**CERTIFICATE OF APPROPRIATENESS**

**Property:** 125 North Street, lot 2, Osceola Subdivision. The property includes a historic 1,579 square foot, one-story brick veneer wood frame single-family residence and a detached shed situated on a 5,000 square foot (50' x 100') interior lot.

**Proposal:** Alteration – Construct a two story rear addition to a contributing one story house. Repair and replace windows, with some changes to window openings and placement.

**Basis for Issuance:** HAHC Approval  
**Effective:** October 23, 2014

### WEST SIDE ELEVATION

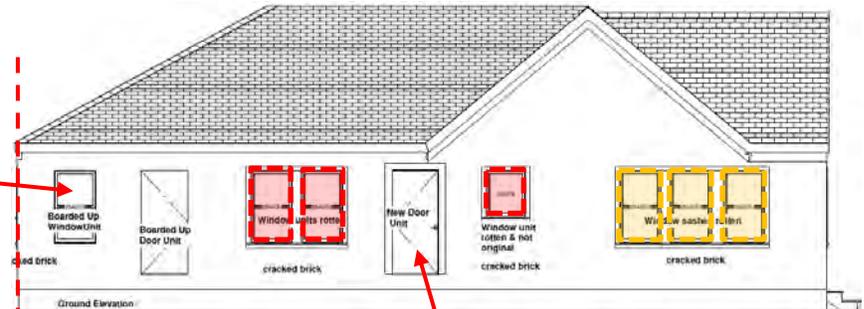
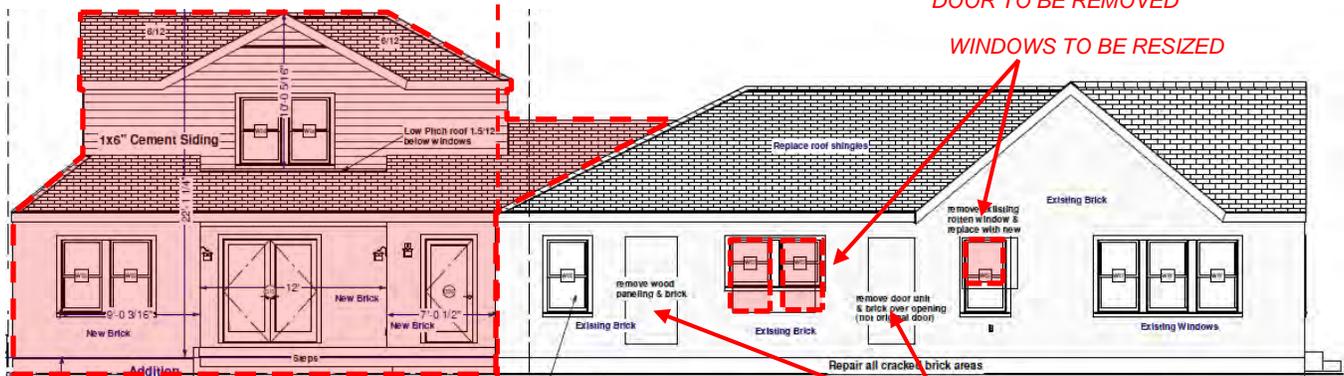
WINDOW OPENING TO BE EXPOSED AND NEW WINDOW INSTALLED

DOOR TO BE REMOVED

WINDOWS TO BE RESIZED

EAST SIDE ELEVATION

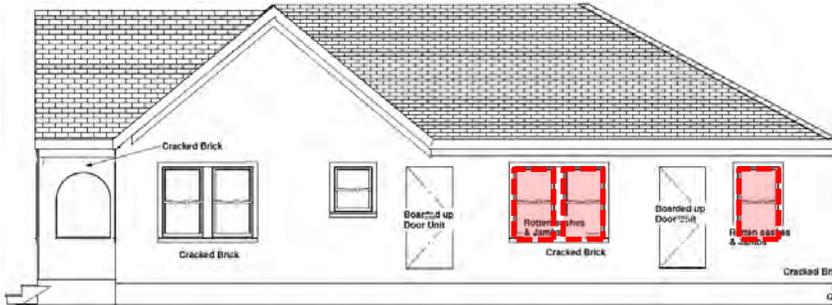
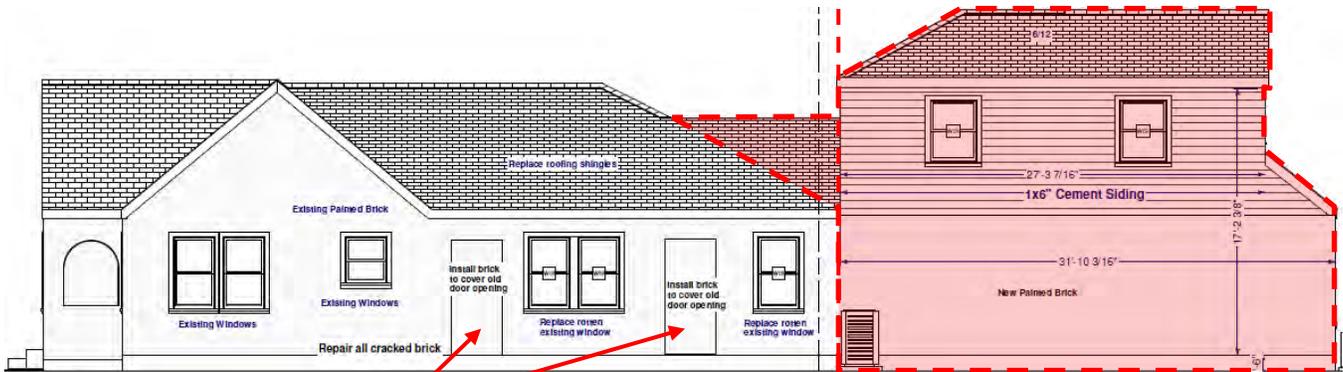
OPENINGS TO BE BRICKED IN

JAMB TO BE RETAINED; SASHES TO BE REPLACED

WINDOW UNIT TO BE REPLACED

OPENINGS TO BE BRICKED IN

WINDOW UNIT TO BE REPLACED

**EAST ELEVATION**

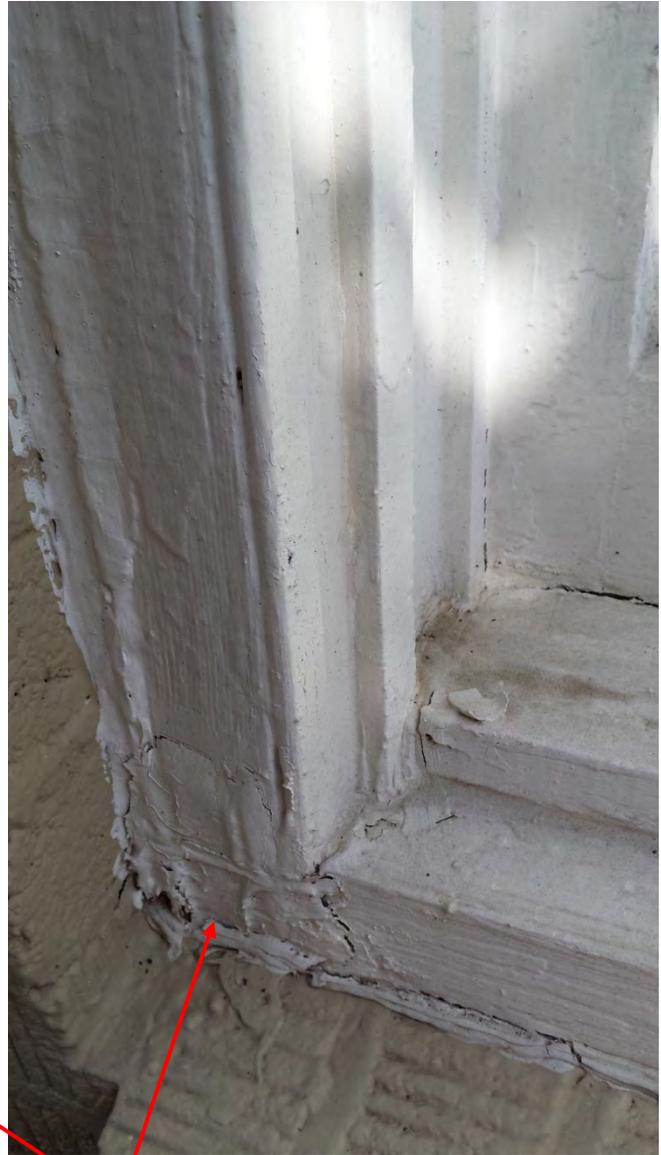
*WINDOWS TO  
BE RETAINED*

ROT COVERED BY  
CAULK AND PAINT
